MEMORANDUM

SUBJECT: Preliminary Report – Zoning Commission Case No. 09-06 (“Arbor Place”) Consolidated Planned Unit Development and Map Amendment Land in Square 4268 @ New York and Montana Avenues

DATE: April 3, 2009

ZONING COMMISSION
District of Columbia
CASE NO. 09-06
EXHIBIT NO. 13

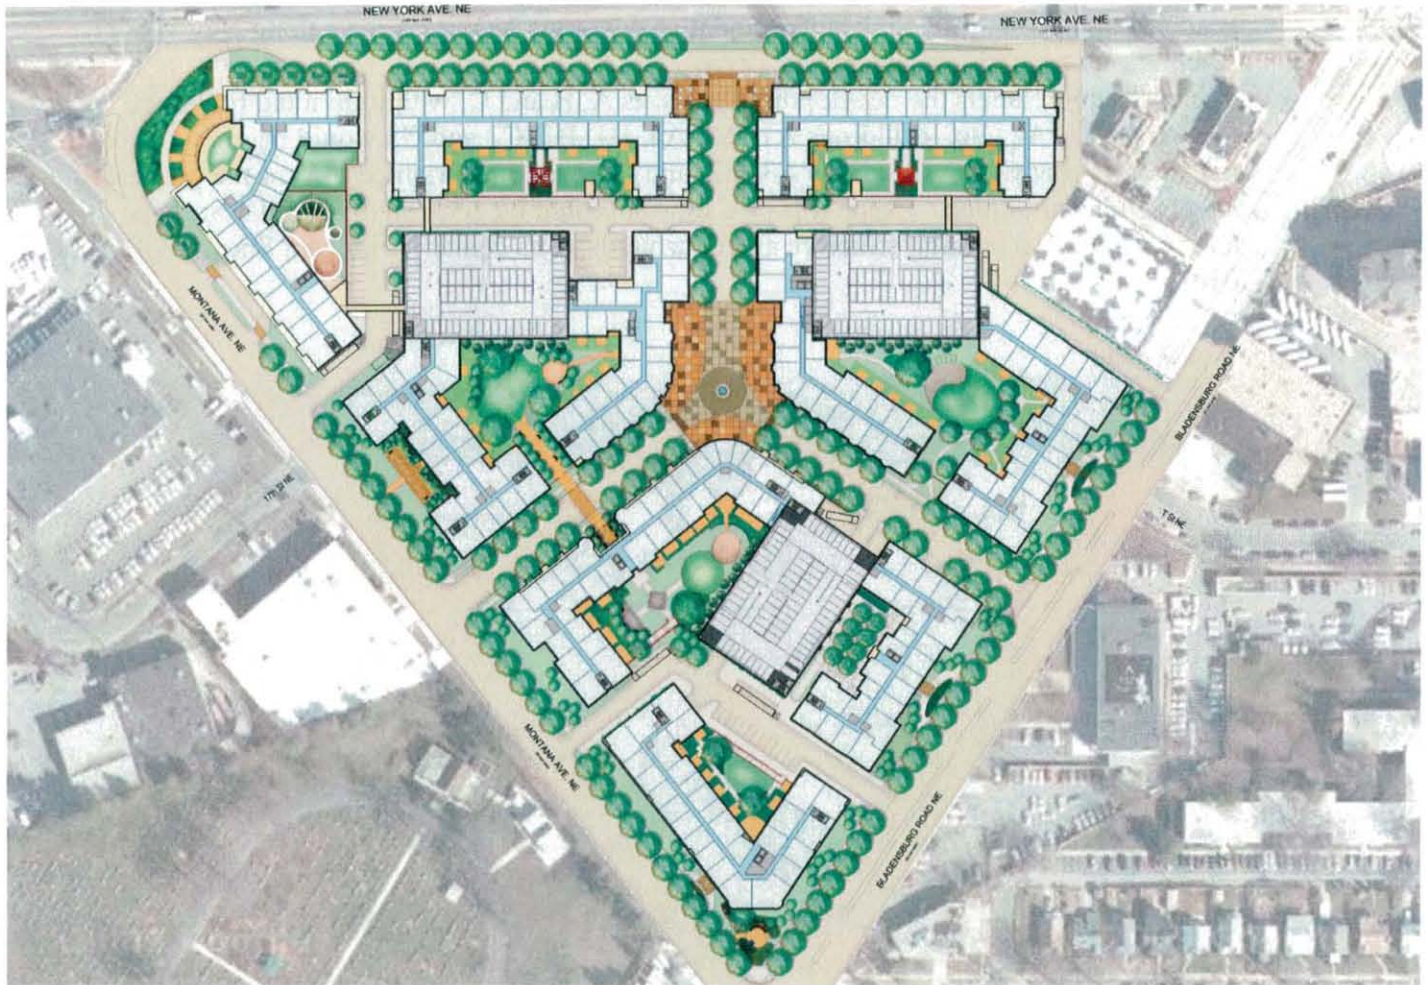
OP has asked the applicant to provide additional information on the type and status of the financing commitments it is seeking; to provide floor plans showing the location and type of the affordable units in each building; and to explain possible conditions inhibiting the even distribution of the affordable units among all proposed buildings.

The applicant should separately quantify the hardscaped and the vegetated open space. It should also note what, if any trees, landscaping or hardscaping it expects the District government to maintain.

OP will work with the applicant to explore design alternatives that reduce the scale, symmetry and repetition of the New York Avenue façade. On Bladensburg Road and Montana Avenue the massing and color of the facades appear somewhat institutional. The use of varying the brick used in different building, reducing the thickness of the cornice and brackets on some of these buildings, and varying the rooflines of the buildings should be explored. The applicant should also provided finished perspective drawings of the buildings, and larger-scale illustrations of street level elements of all buildings facing interior or exterior streets.

OP has asked the applicant to explore including additional green roofs for buildings or for parking structures [Sheet L01], or more pervious paving for the internal roadways, alleys, surface parking areas, sidewalks and walkways.
